## **Chatham County Planning Board Agenda Notes**

**Date:** January 5, 2021

**Agenda Item:** VII-2

**Subject:** A request by Mark Ashness, P.E., on behalf of Laurel Ridge Development, Inc. for subdivision Final Plat review and approval of Laurel Ridge Phase 2B, consisting of 14 lots on 67 acres, located off Old NC 87, SR-1547, Hadley Township, parcel #86169.

*The following map shows the location of this phase*

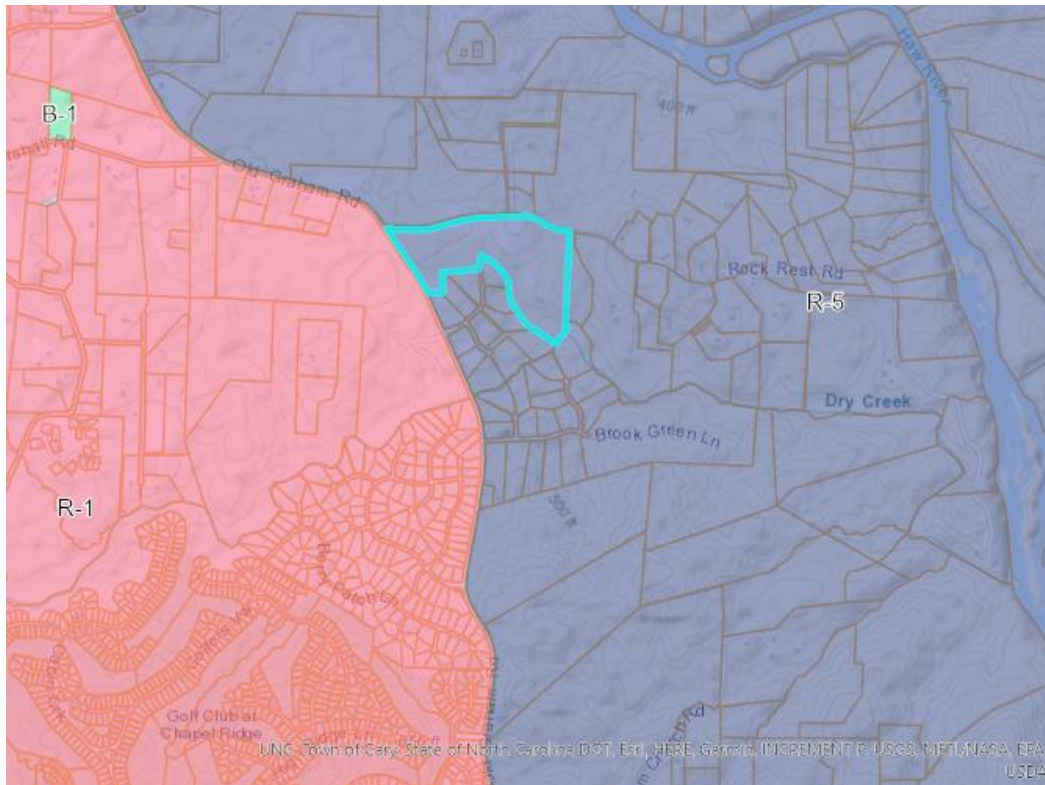
Several residents spoke during public input about their concerns with this phase of the development. Daniel Amero commented that larger buffers are needed since the area floods, the developer has bulldozed a pathway alongside his property that wasn't on the plan and has encroached onto his property in area 250' long and 8' in width. He was concerned with the project because he believes the developer is reckless.

Elaine Chiosso had concerns with trespassing with a bulldozer and the notice of violations for sedimentation and erosion control issues. She also questioned what type of guarantee can the developer provide that the erosion control problems won't continue and whether the developer will be respectful of property lines.

Mr. Ashness explained none of the lots will be accessed by Rock Rest Road. There were concerns from the Board about potential flooding on Lot 35 and the lot being inaccessible at times. Mr. Ashness stated the ridgeline is on the other side of Rock Rest Road and it's not a large drainage area, it's flat and low and there's relief on Lot 35R and shouldn't be an issue from an elevation point.

Board members asked if the developer would increase the buffer on Dry Creek from 50' wide to 100' wide and Mr. Ashness responded that he would need to discuss that with his client. The Board postponed voting on the final plat until the January 5, 2021 meeting to give him time to communicate with the developer. Since the December 1, 2020 meeting the developer agreed to place an additional 50' voluntary buffer and the revised plat can be viewed on the following website - <https://www.chathamnc.org/government/departments-programs/planning/rezonings-subdivision-cases/2020-items/laurel-ridge-phase-2b-final-plat-4805> .

Mark Ashness, P.E. spoke on behalf of the developer. He stated they have eliminated roads and lots from the preliminary plat and reduced the impervious surface. There was a substantial communication breakdown with the contractor that was doing the under brushing and it was a problem that they breached the property line of Mr. Amero. Mr. Ashness commented that about 700 square feet was breached on Mr. Amero's property and there's no excuse for those impacts. He also noted that the erosion control violations have been addressed with the County.
